Appl. No. 10/616,943  
Amdt. dated November 4, 2004  
Reply to Office action of August 4, 2004  
Page 8

Docket No. 2957-136  
 Superconducting rotor with cooling  
 system  
 REPLACEMENT SHEET

Fig. 1

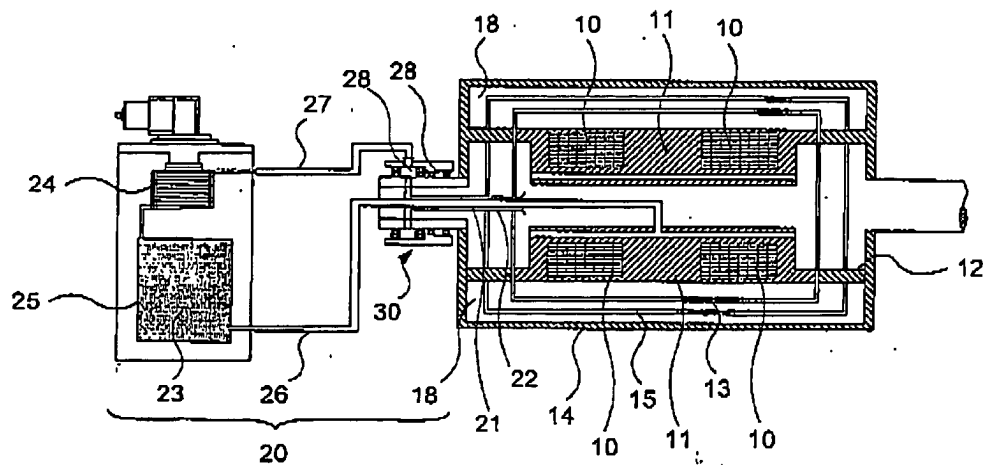
Attached is a correct Fig. 1 adding the label "PRIOR ART" thereto.

PRIOR ART
